Amendments to the Drawings:

FIG. 1

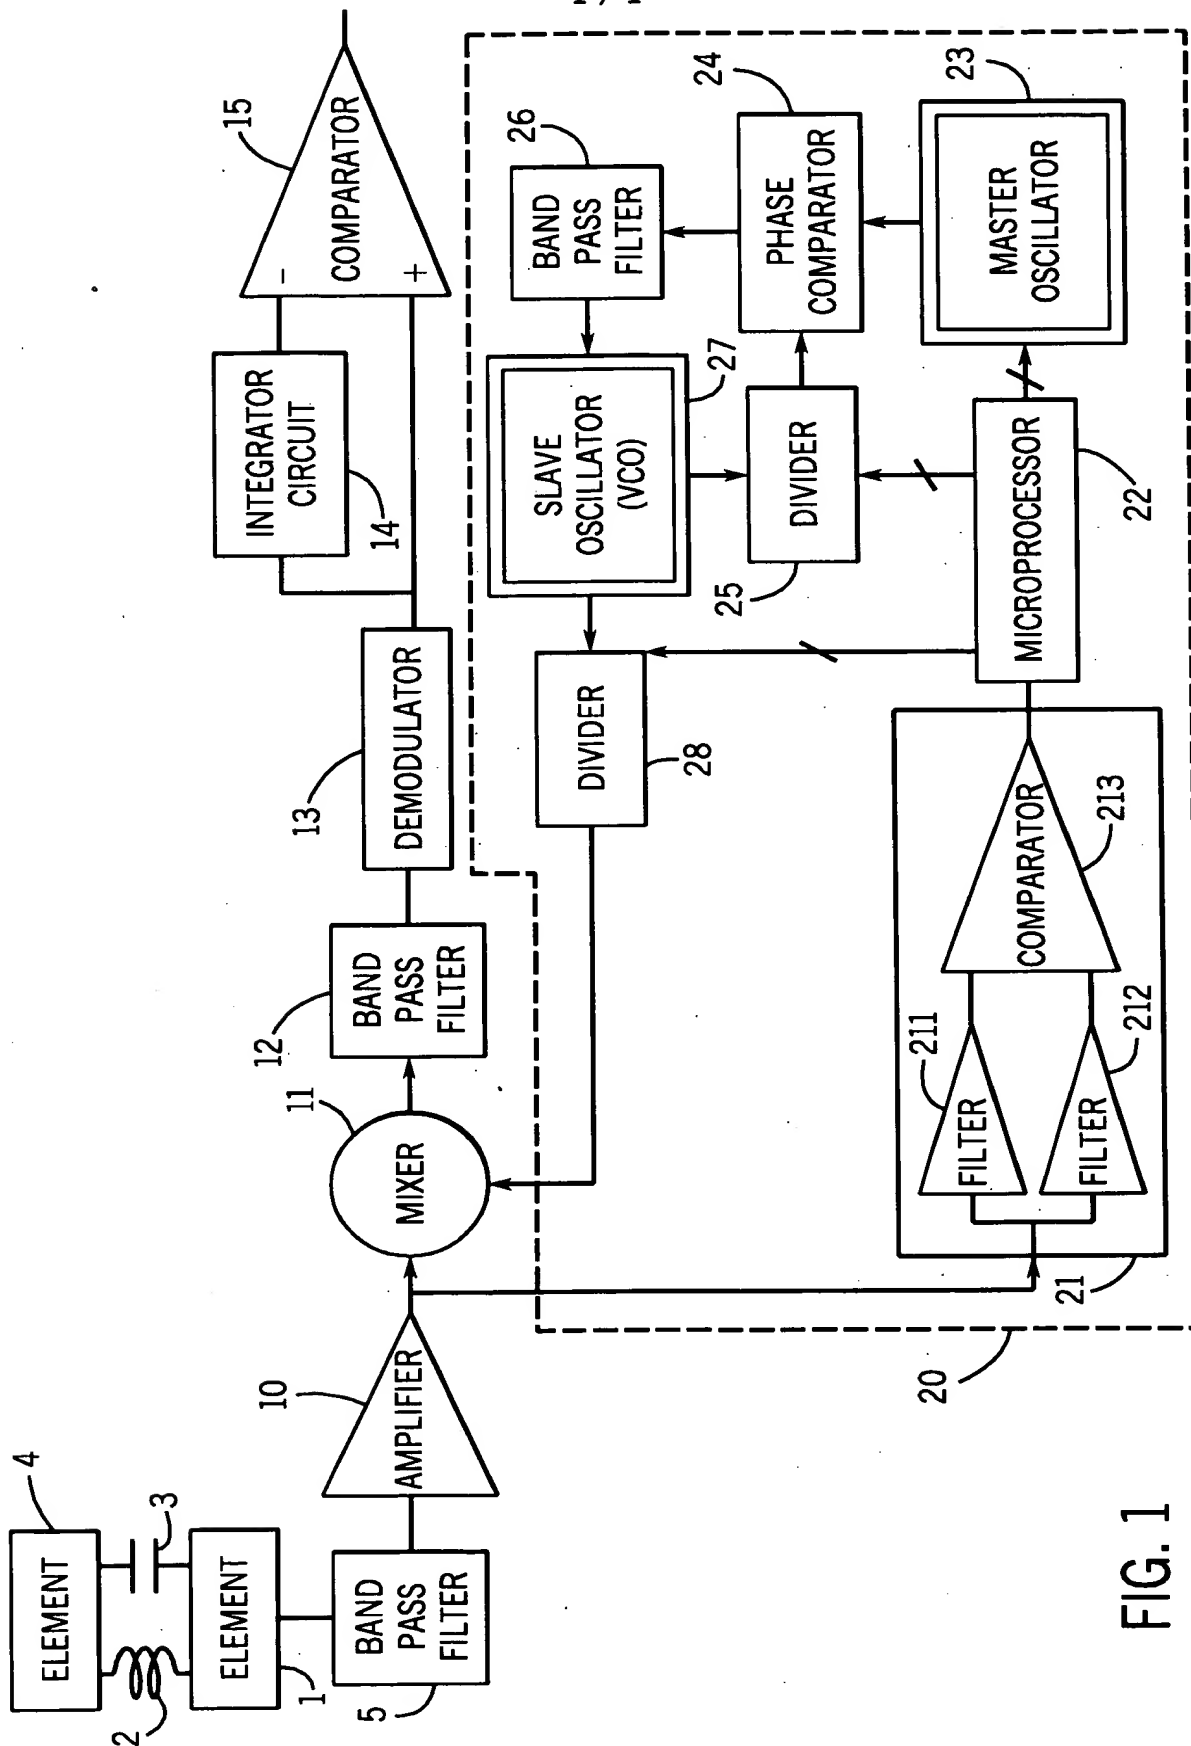
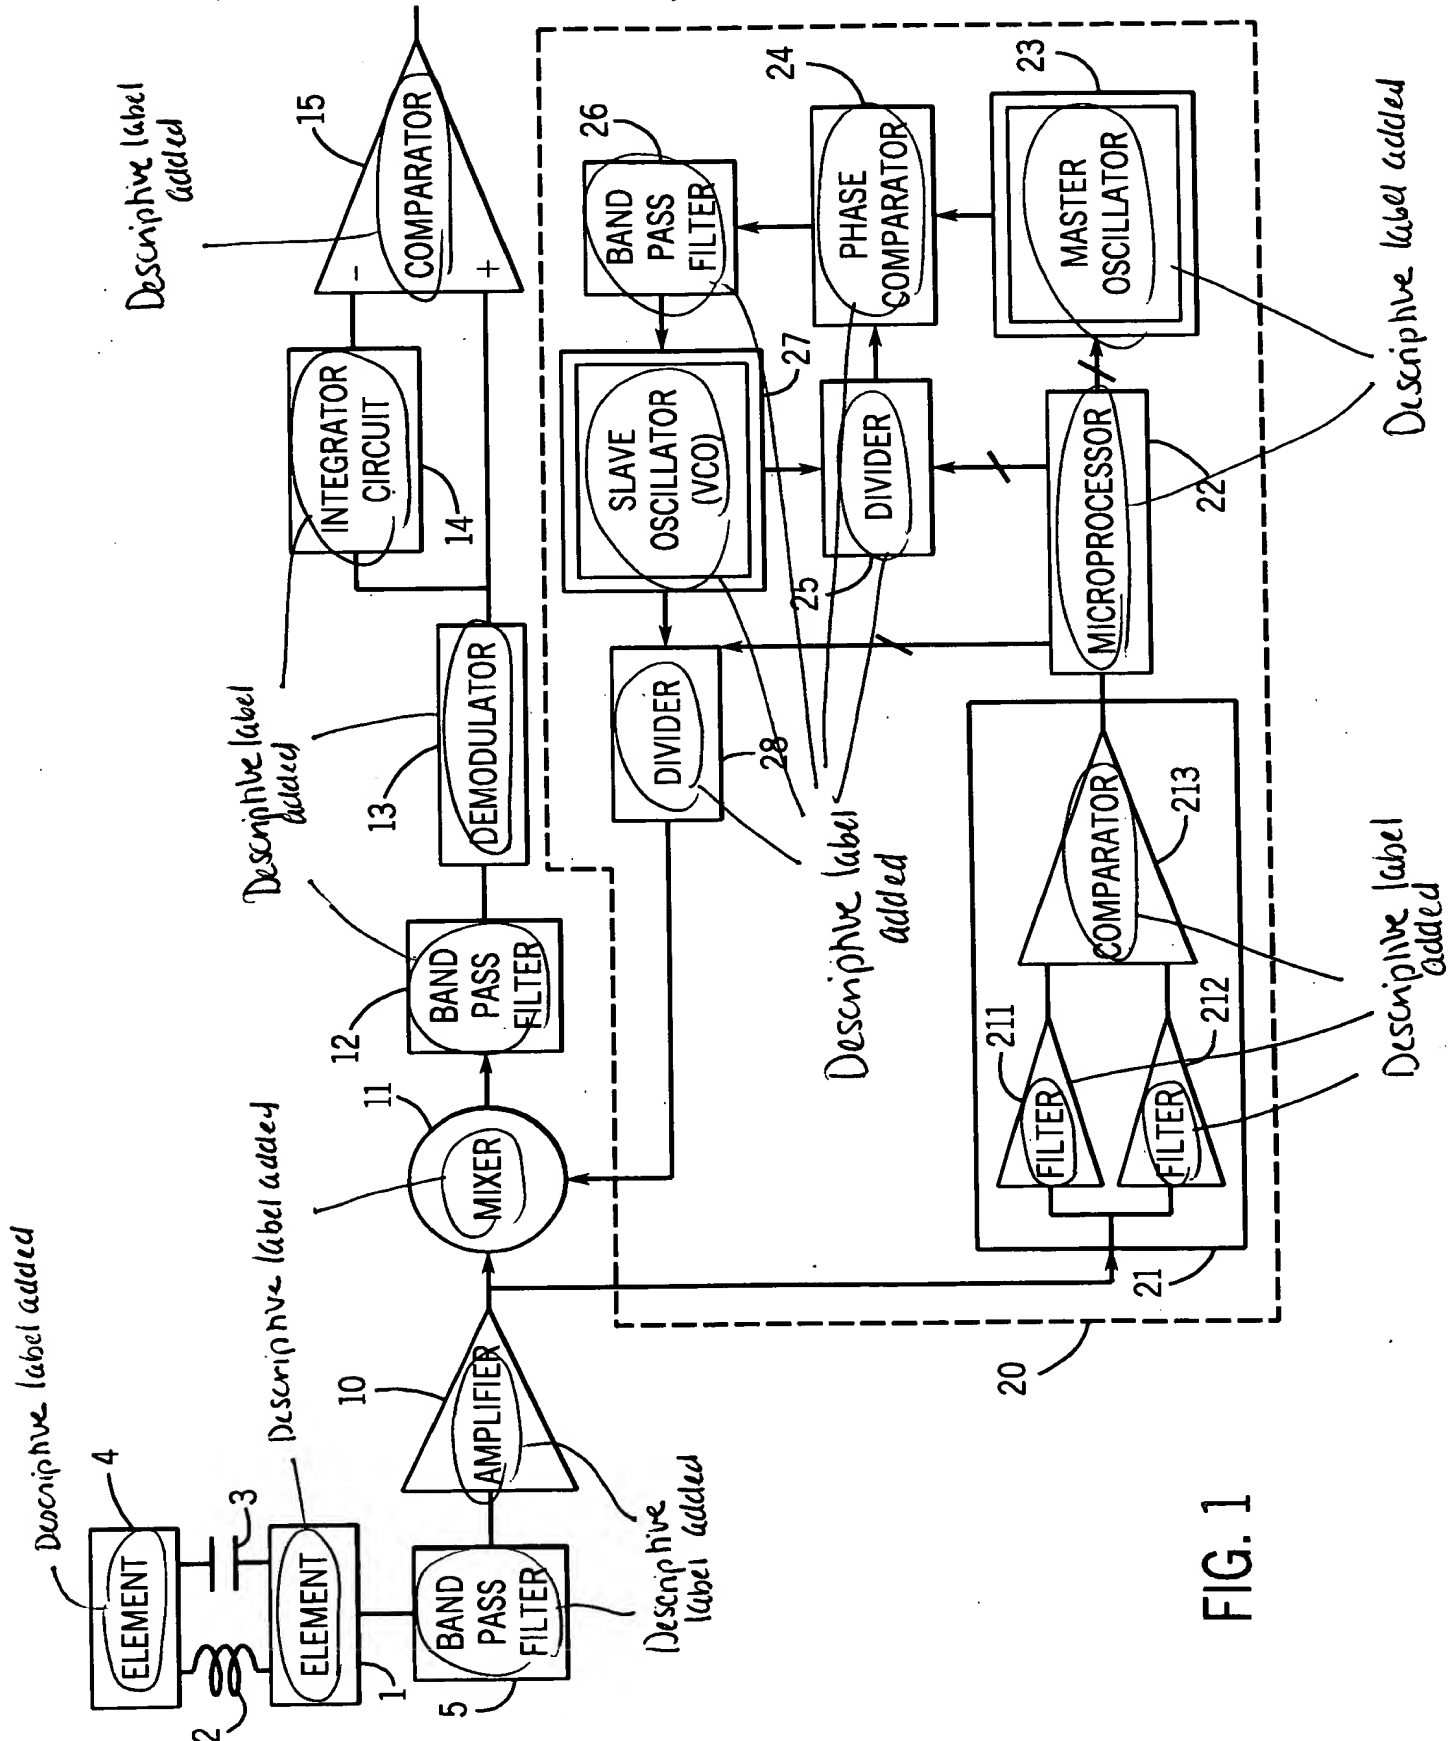
The drawing sheet attached in connection with the above-identified application containing Figure 1 is being presented as a new formal drawing sheet to be substituted for the previously submitted drawing sheet or sheets. The drawing figure 1 has been amended. Appended to this amendment is an annotated copy of the previous drawing sheet which has been marked to show changes presented in the replacement sheet of the drawing.

The specific changes which have been made to Figure 1 are the addition of descriptive labels to elements, in particular: block 1 has been labeled ELEMENT, block 4 has been labeled ELEMENT, block 5 has been labeled BAND PASS FILTER, block 10 has been labeled AMPLIFIER, block 11 has been labeled MIXER, block 12 has been labeled BAND PASS FILTER, block 13 has been labeled DEMODULATOR, block 14 has been labeled INTEGRATOR CIRCUIT, block 15 has been labeled COMPARATOR, block 211 has been labeled FILTER, block 212 has been labeled FILTER, block 213 has been labeled COMPARATOR, block 22 has been labeled MICROPROCESSOR, block 23 has been labeled MASTER OSCILLATOR, block 24 has been labeled PHASE COMPARATOR, block 25 has been labeled DIVIDER, block 26 has been labeled BAND PASS FILTER, block 27 has been labeled SLAVE OSCILLATOR (VCO) and block 28 has been labeled DIVIDER.
